TECH-NEWS

Drive Cable Breakage By The Control Panel

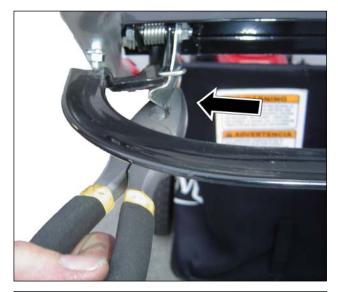
The one side effect if the Bail Stop Spring is adjusted too loosely is that the bail falls down too easily and it becomes less operator friendly. HOWEVER we have discovered a second side effect that it can cause premature failure of the drive cable for the transmission.

The combination of the bail going past the Bail Stop Spring too easily and a cable that has developed a kink will eventually cause the drive cable to fail at the ball.

The first step is to adjust the tension of the Bail Stop Spring so that it will keep the bail in the operating position and yet allow the bail to fold down in the event of a high force pushing it down.

The Bail Stop Spring can be easily adjusted by bending it with a set of pliers.

We also recommend using a small amount of grease on the spring for smooth operation of the bail.
